Access Compliance Report

Public Rights-of-Way

(Curb Ramps)

Intersection ID: 18881	Main Street: HONEGGER_DR	Cross Street: REDCOAT_DR	Location: SE
ADA ID: D863BC99ED1B	Ramp Type: Directional1	Initial Pass/Fail: Fail	Overall Compliance: No
		Severity Score: 12.5

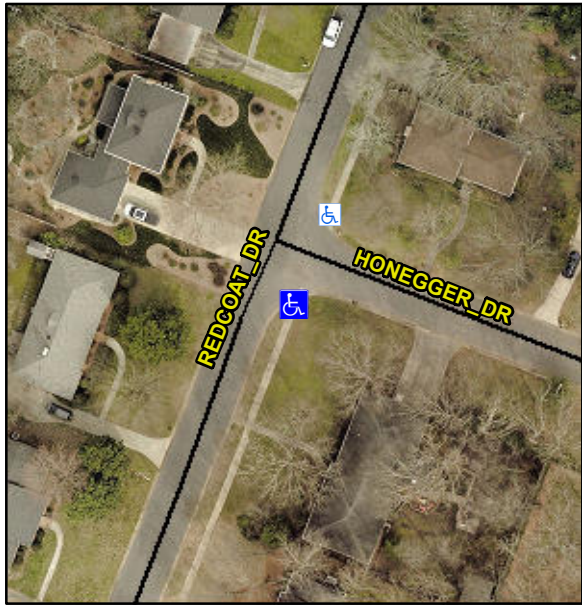
Codes/Mitigation Info/Possible Solution			Field Measurements/Component Compliance							
	Possible Solutions:		Compliance			Description			Data	
	Remove & Replace Entire Ramp.		N/A	Ramp Length (in)	68.0	N/A	Grade Break?	N/A		
			Yes	Ramp Width (in)	57.0	N/A	Grade Break Slope (%)	0.0		
			Yes	Ramp Slope (%)	7.1	N/A	Grade Break XSlope (%)	0.0		
			No	Ramp XSlope (%)	5.5					
			N/A	Flare Type LT	N/A	N/A	Flare Type RT	N/A		
			N/A	Flare Slope LT (%)	N/A	N/A	Flare Slope RT (%)	0.0		
			N/A	Flare Traversable LT?	N/A	N/A	Flare Traversable RT?	N/A		
			N/A	Landing Length (in)	0.0	N/A	DWS Provided?	N/A		
			N/A	Landing Width (in)	0.0	N/A	DWS Contrast?	N/A		
Surveyor Notes: N/A			N/A	Landing Slope (%)	0.0	N/A	DWS Length (in)	N/A		
			N/A	Landing X Slope (%)	0.0	N/A	DWS Full Width?	N/A		
			N/A	Landing Curb? (Y/N)	N/A	N/A	DWS Offset LT (in)	N/A		
			N/A	Shared Landing?	N/A	N/A	DWS Offset RT (in)	N/A		
			N/A	Gutter Ponding?	0.0	N/A	Gutter Slope (%)	N/A

N/A	Gutter Lip Ht (in)	0.0	N/A	Gutter X Slope (%)	N/A		
			N/A	Painted X Walk1?	No		Road Slope (%)	2.4		
				X Walk 1 Direction	To NE		Road X Slope (%)	1.2		
				X Walk 1 Width (in)	N/A		Clear Space?	N/A		
				X Walk 1 Slope (%)	2.4	N/A	Clear Space to XWalk (in)	N/A		
PROW/ADA: R304.5.3				X Walk 1 X Slope (%)	1.2	N/A	Storm Grate/Utility Hazard?	N/A		
			N/A	Ramp inside XWalk1?	N/A		Storm Grate/Utility Type			
			N/A	Any Obstructions?	N/A			N/A		
				Obstruction Type		Yes	Surface Condition? (G/P)	Good		
					N/A	N/A	Curb Slope (%)	8.3		
	Total Cost:		\$	1600.00

Remove & Replace Entire Ramp.
